Coal Free Southern Highlands Inc.

Hume Coal Project
Independent Planning Commission
February 11th, 2019

Response to the DPE assessment of the
Hume Coal Project

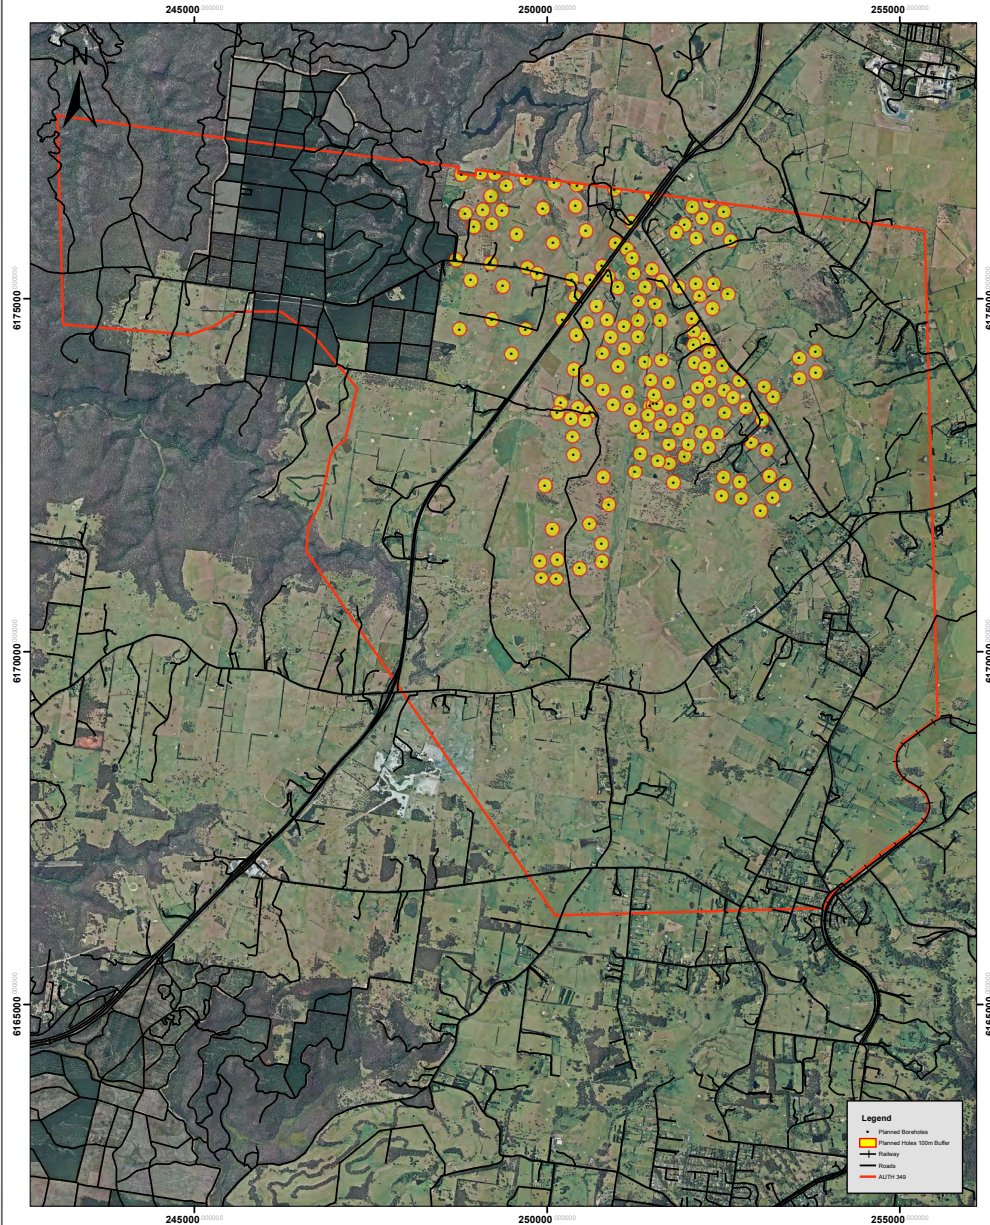
150 drillhole locations nominated
 90 to be selected
 100 metre radius of flexibility

DRE rejected this proposal
 July 2014 – 25 holes approved

Just 3 holes were eventually drilled, all west of the highway

FIGURE 18 2011 2D SEISMIC SURVEY LINE LOCATIONS

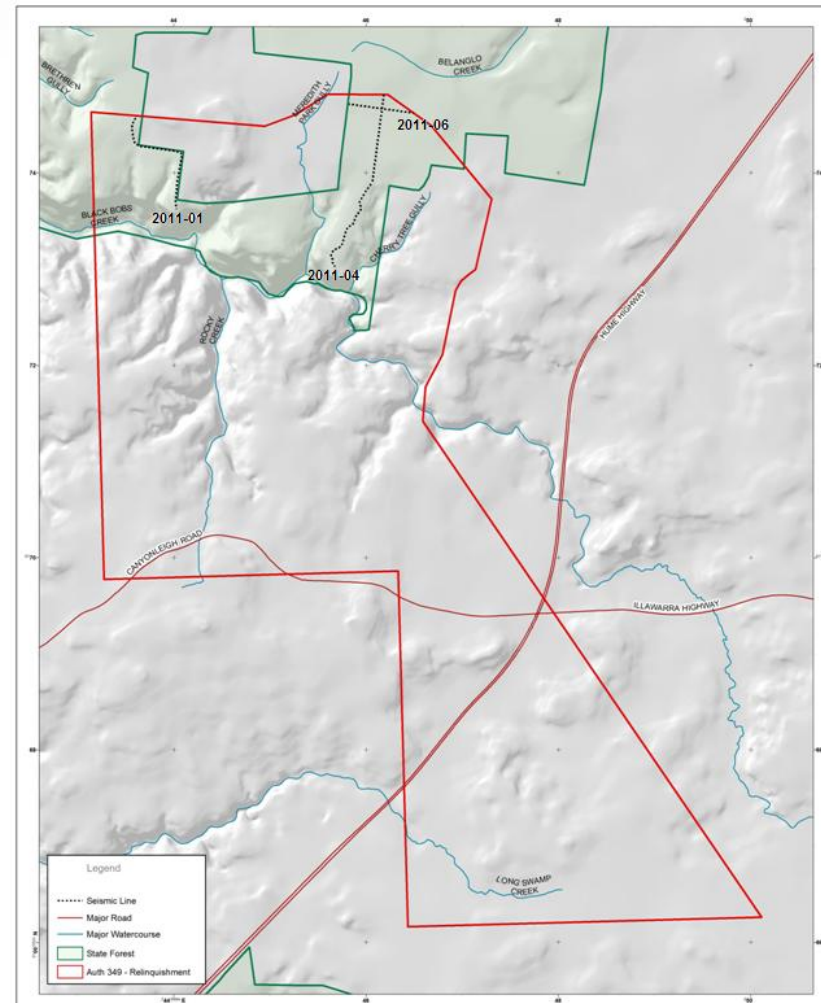
- Seismic Data demonstrates that:
 - faulting places the Hawkesbury Sandstone horizontally against the Wongawilli Coal
 - The structure of the top of the Wongawilli coal does not “...dip gently from west to east...at...a grade of 1 in 100” (Fitzsimmons & Doyle, 2017). Rather, it is faulted and is involved in both anticlinal and synclinal features
 - The Wongawilli Coal is highly fragmented into separate and non-contiguous bodies across faults.

- Geological structure within AUTH 349 is much more complex than the Operator has portrayed in the proposals.

Cockatoo Coal - 2011 Belanglo 2D Seismic Survey
Line 2011-04 Interpreted Section - Migrated Stack with Spectral Enhancement
Scale 1:5,000 V/H approx. 2

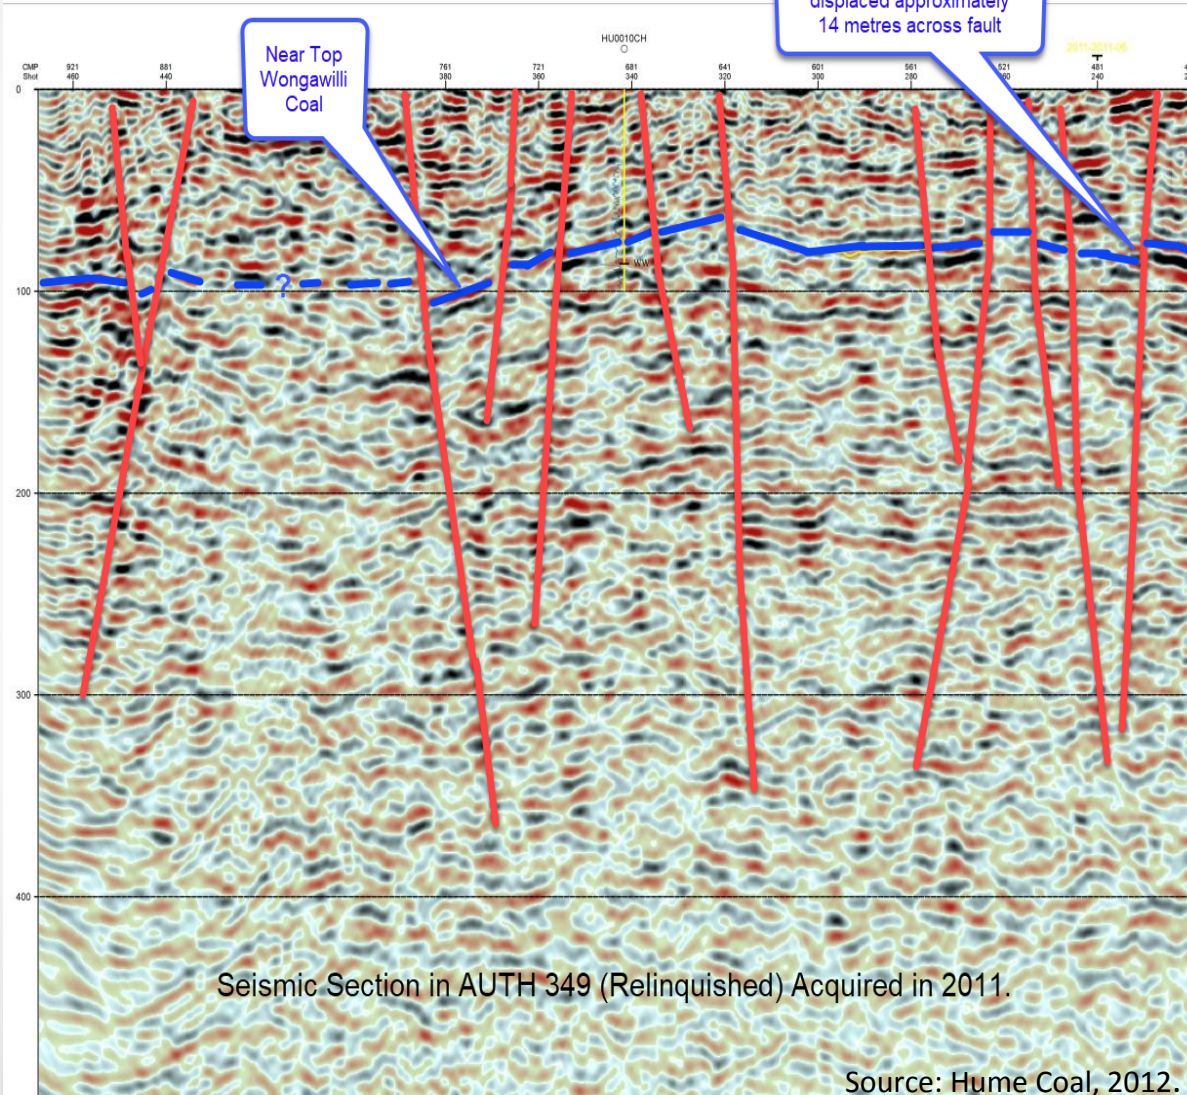
Additional seismic lines demonstrating faulted geological structure

2. The operator's proposal for the presence of a widespread aquitard isolating the Hawkesbury Sandstone aquifer from the Wongawilli Coal is invalid because fault throws of up to 18 metres not only fragment the aquitard, they horizontally juxtapose the Wongawilli Coal and the Hawkesbury Sandstone.

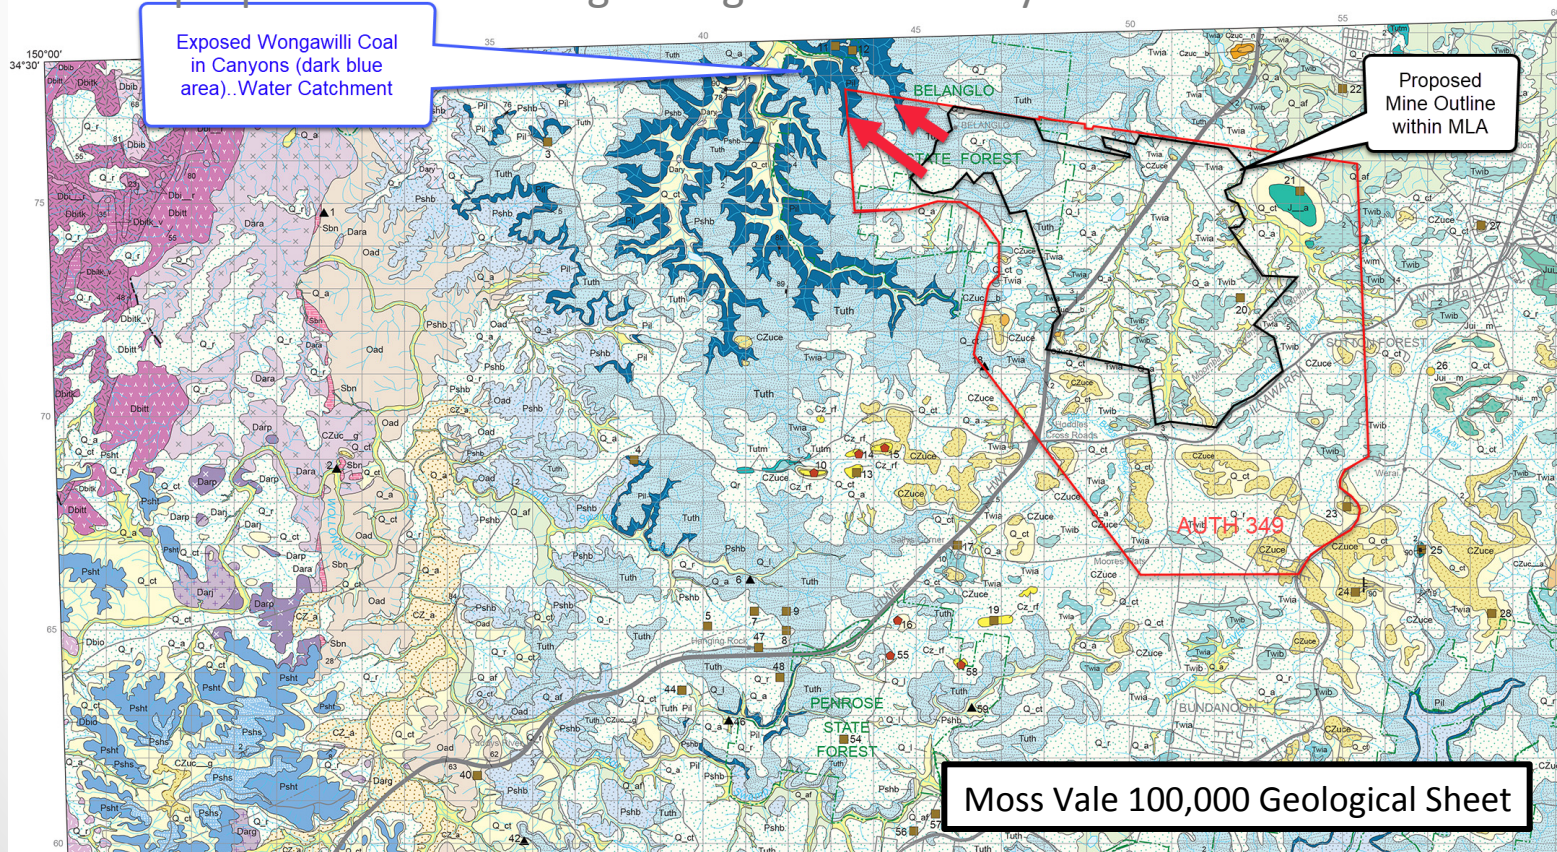
The Wongawilli Coal is exposed in gorges of Wingecarribee River tributaries (which flow into the Wollondilly River of the Burraborang Water Catchment) in and around the north-western part of AUTH 349.

Consequently, the Lake Burraborang Water Catchment is a receptor to contaminants from the proposed mine through the ground water system
